From: Mail <mail@highlights.co.uk>
Sent: Tuesday, June 6, 2023 3:35 PM
To: Facilities Dir. - HRFC <facilitiesdirector@havantrfc.co.uk>
Subject: RE: APP/23/00345 - Hook Lane Rugby Ground, Hooks Lane, Havant
Importance: High

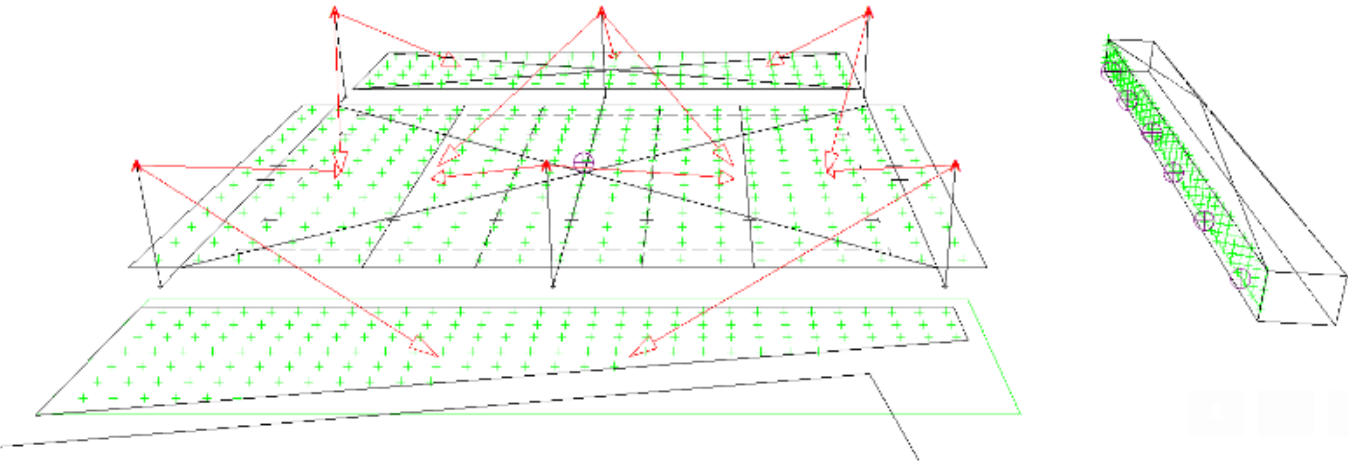
1. The lights will not cause glare to neighbouring properties and users of Hook Lane.

Further to consultation with the 2021 Institute of Lighting professions guidance note document, calculation application fields of a horizontal and vertical orientation have been inserted into the site specific lighting design regarding Havant Rugby Club. To ensure the accurate positions of the calculation application fields, Google Earth imagery has been scaled accordingly via AutoCAD 2021 software, prior to import into Philips Calculux Lighting Design software.

The “green wall” applied to the houses pictured below on Hook Lane, represents the boundaries of the residential properties to which the 101 metre long lighting calculation “Vertical Property Grid” is based on. The green vertical calculation grid points start at 1.5 metres above ground level. This is to simulate the height of the centre of ground floor windows of the properties. The calculation grid points occur every three metres horizontally and every metre vertically, up to six metres high. It is the described high frequency of grid points, that ensures correct examination to the adjoining properties for vertical light spill. Please note; large natural barriers such as trees and fencing have not been considered whilst carrying out lighting calculations.

The 6 No. purple circles with crosses within the diagram above represent “observer points” used to calculate the predicted glare intensity at individual points across the boundaries of the residential properties within the Lighting Design.
